**BRIDGEPORT AT LAKE SUMTER RESIDENT  
PRESENTATION TO VCDD5 AND VCDD6  
JUNE 2, 2017**

**A BLS Resident Perspective of Issues at the Entry and Exit  
Gate Area and the Multi Model Path Crossing**

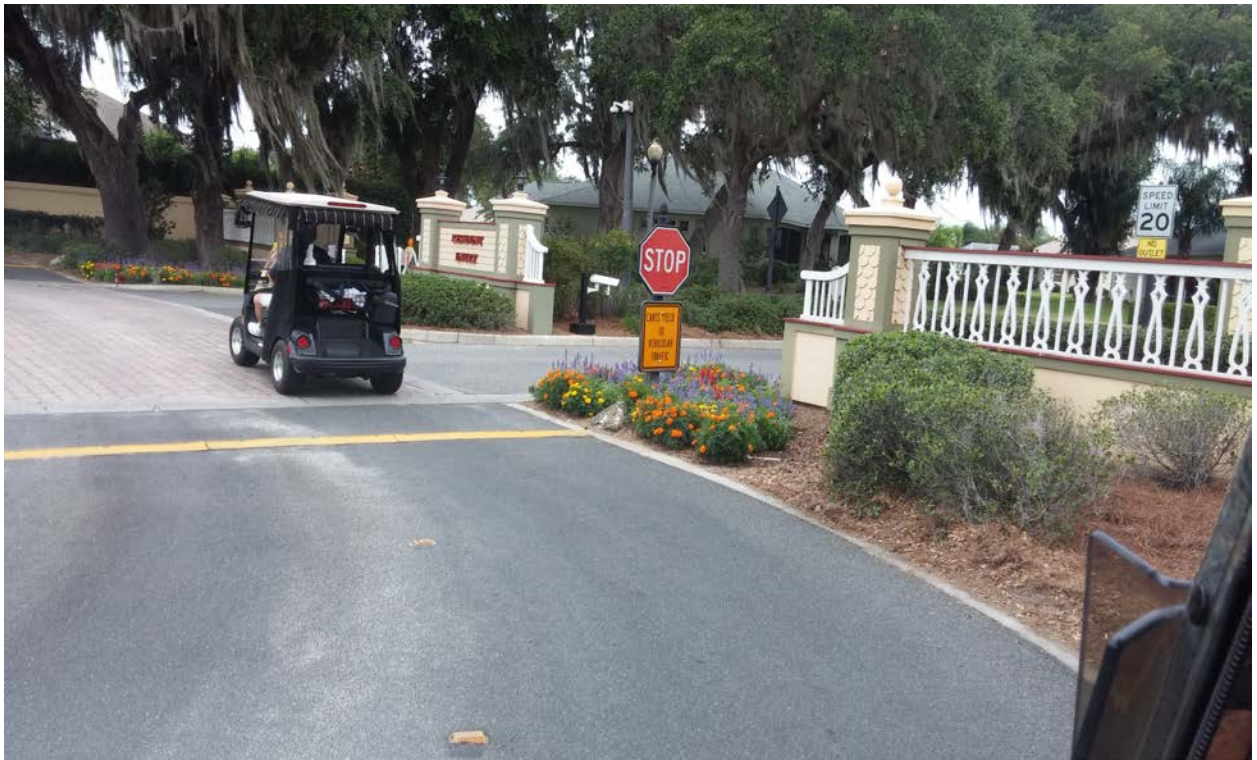
**Photo A.** Taken from a golf cart positioned on the mm path right after the curve approaching the stop area for carts heading toward Arnold Palmer Restaurant.

An exiting vehicle, if not near the gate, can be difficult to see through the lattice work.

**Photo B.** As Photo A, but the golf cart is now located at the stop position.

An exiting vehicle (especially a golf cart) that is near the gate cannot be seen as it is hidden by the Resident Entry sign and the shrubs.

**Photo C.** Taken from a golf cart positioned about 20 feet from the **exit** gate leaving the Village.

An exiting vehicle “might” see a cart waiting to cross in front of the entry gate, but cannot see a cart that is part way across the mm path.

**Photo D.** Taken at the **exit** gate when leaving the Village.

An exiting vehicle near the gate cannot see a cart waiting to cross in front of the entry gate, nor can the vehicle be seen by a cart beginning to enter the multi modal path on their left. A cart part way across will not be seen.

**Now is the time to finally address this line-of-sight issue at BLS. Removal or lowering of the entry sign, removal of the shrubbery, and lowering of the electrical boxes into a “well” should open up the area for all traffic, and relieve the considerable anxiety experienced by those entering, leaving, and crossing through the area.**
